CERTIFICATE OF APPROPRIATENESS

Property: 7707 Lakewind Street, tract 35, block 21, Glenbrook Valley Subdivision. The property includes a historic 3,469 square foot, one-story wood frame single-family residence and an attached garage situated on a 35,524 square foot interior lot.

Proposal: Alteration – Windows

WINDOW SCHEDULE and DIAGRAM

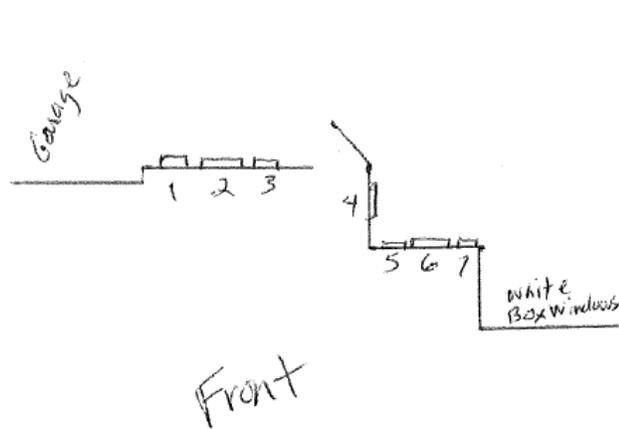
Windows/Doors: The applicant proposes to replace 7 windows on the front elevation of a contributing structure. The replacement windows will consist of composite material and will not require modification of the window openings.

Staff performed a site visit associated with a COA granted in April and found no damage on the windows at that time.

The applicant has not submitted any specific evidence indicating the windows are damaged beyond repair.
